Triassic Park Hazardous Waste Disposal Facility

Meeting held June 8, 1995 in Santa Fe

Triassic Park - Geology/Hydrogeology

Triassic Park - Landfill (use SWB's notes)

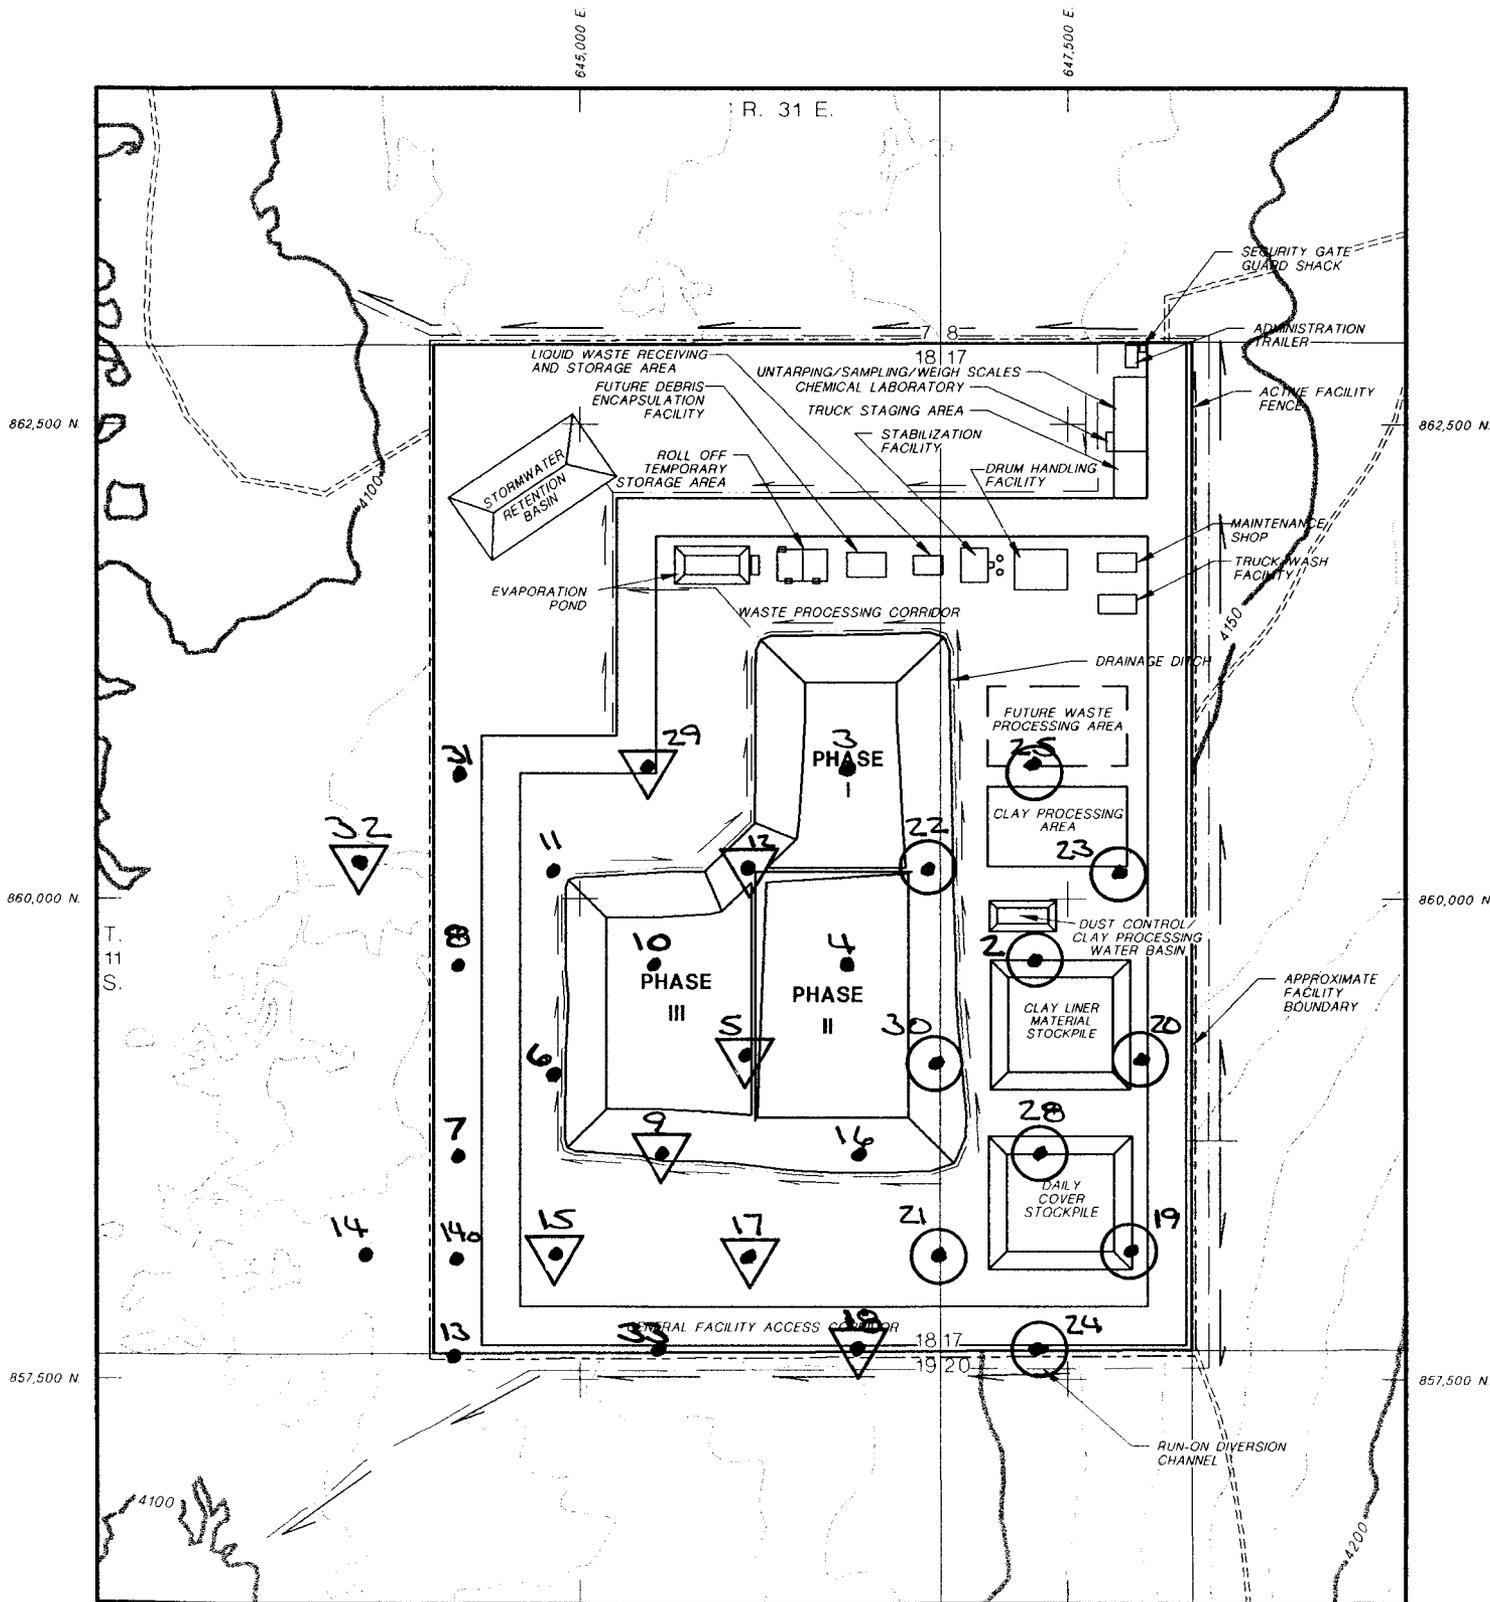
- - borehole location, TD 100', with PB.#, TD in mdst on lith. & GR-N logs
- ▽ - TD in mudstone per lith. log; may be siltst or sandstone per GR-N log.
- - TD in siltst/sandstone per lith. log and GR-N.
